Final Environmental Impact Report

Goodman Logistics Center Fullerton Project

PRJ2019-00173

City of Fullerton, California

Revised Figure 4.11-1b

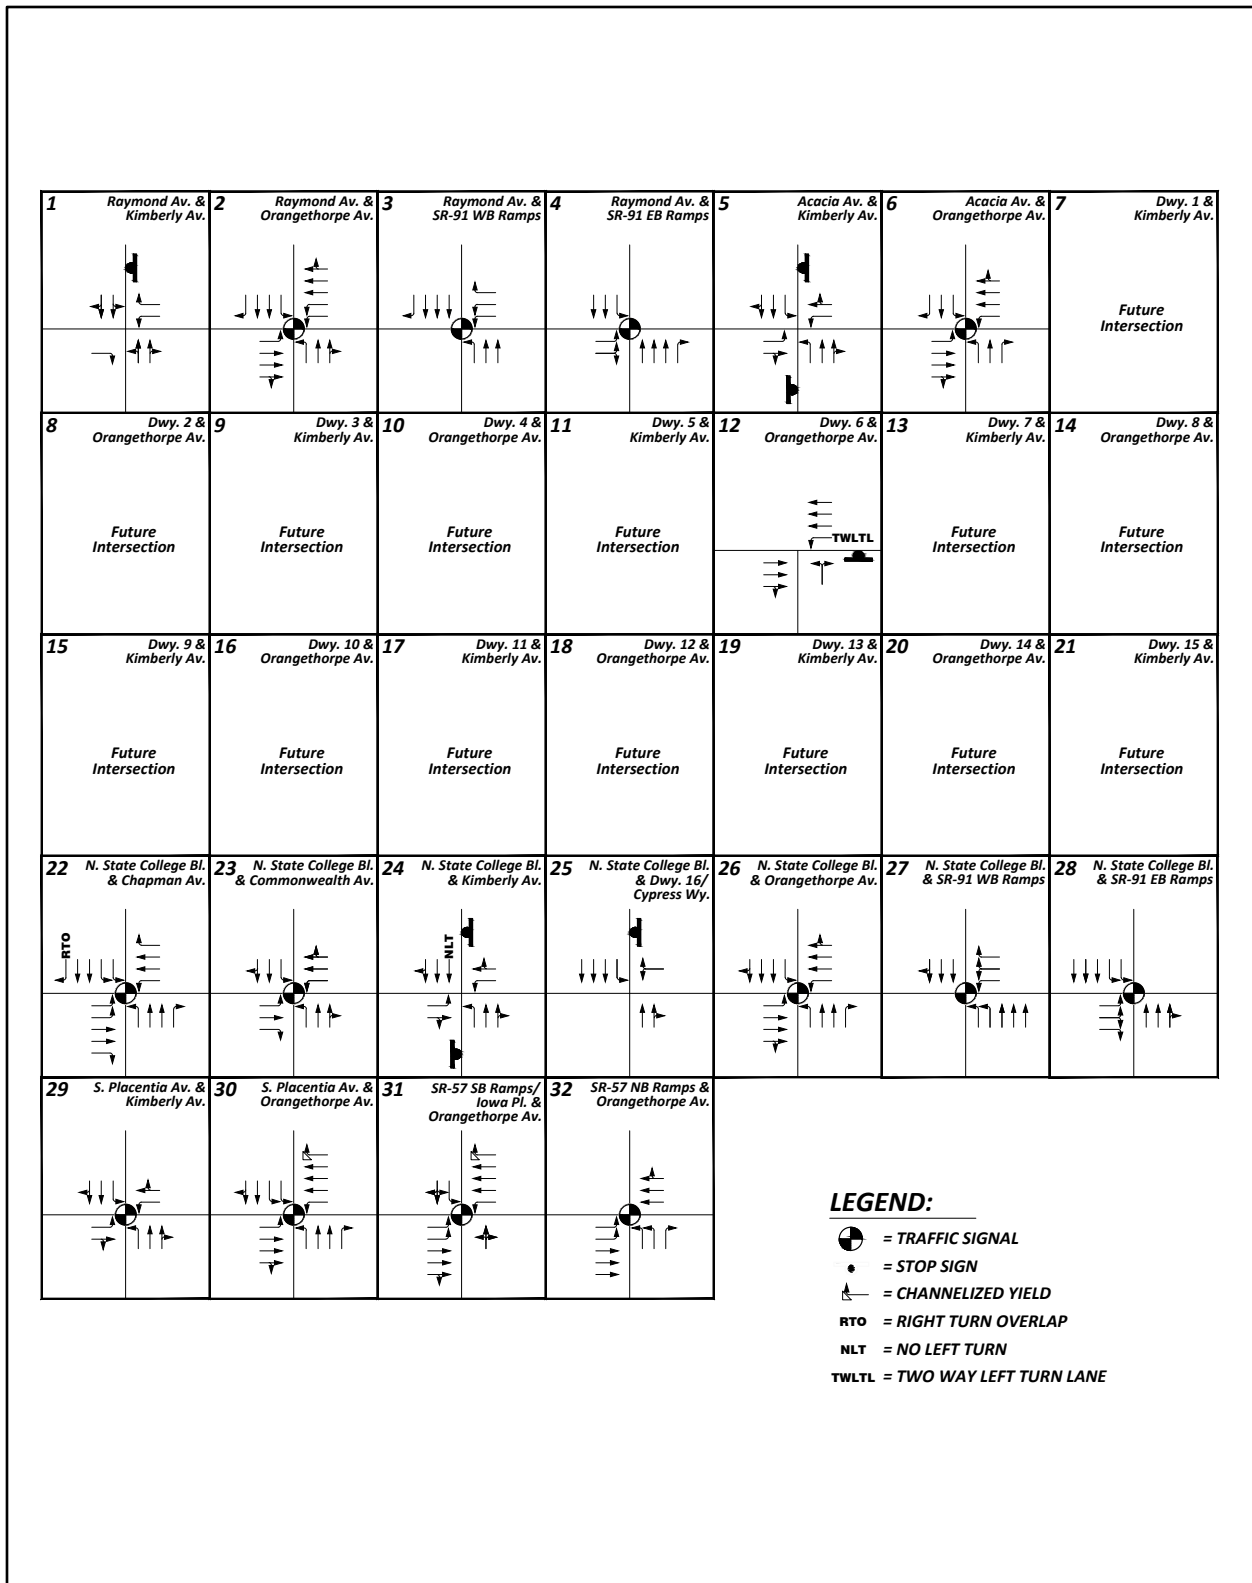
- D-4. This comment correctly identifies that the eastbound lane configuration for Intersection No. 23 (State College Boulevard/Commonwealth Avenue) is shown incorrectly in Figure 4.11-1b, Existing Number of Through Lanes and Intersection Controls, of the Draft EIR. Revised Figure 4.11-b is included in Section 3.0, Clarifications and Revisions, of this Draft EIR.

1. Figure 4.11-1b on page 4.11-5 of the Draft EIR is hereby revised to show the correct eastbound lane configuration for Intersection No. 23 (State College Boulevard/Commonwealth Avenue). Revised Figure 4.11-1b is attached at the end of this section.
